**DRIVEABILITY—ROUGH IDLE AND/OR HESITATION
ON ACCELERATION—VEHICLES EQUIPPED WITH
5.4L OR 6.8L ENGINE ONLY**

**Article No.
03-9-11**

FORD: 2000-2003 E-350, E-450, EXCURSION, SUPER DUTY F SERIES

Figure 1 - Article 03-9-11

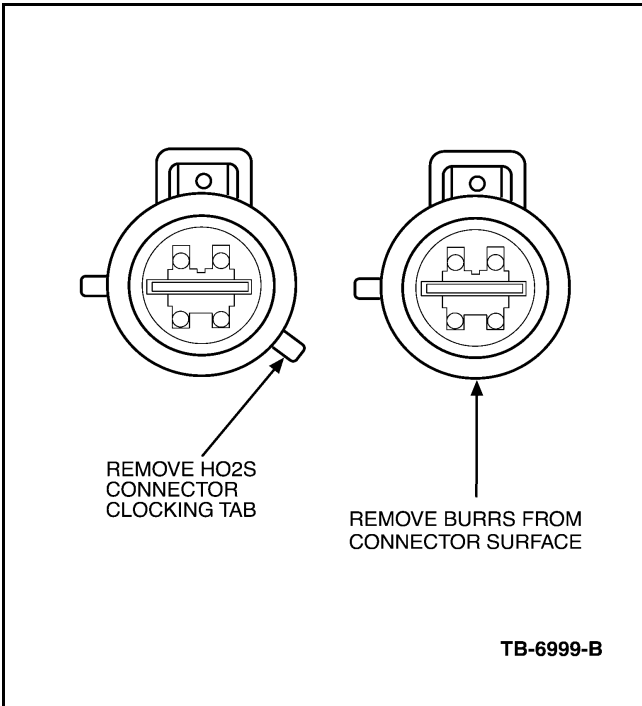
THE NEW HO2S CONNECTOR (BLACK) REQUIRES THAT THE CLOCKING TAB LOCATED AT THE 4:00 POSITION BE REMOVED. REFER TO FIGURE 1 FOR REQUIRED ELECTRICAL CONNECTOR MODIFICATION FOR MATING WITH VEHICLE WIRING HARNESS. FOLLOWING THE MODIFICATION, VERIFY THAT CONNECTOR MATES FULLY AND LOCKING FEATURE IS ENGAGED. THE ELECTRICAL CONNECTOR HARD-SHELL COLOR OF THE NEW HO2S SENSORS WILL BE BLACK INSTEAD OF GREEN.
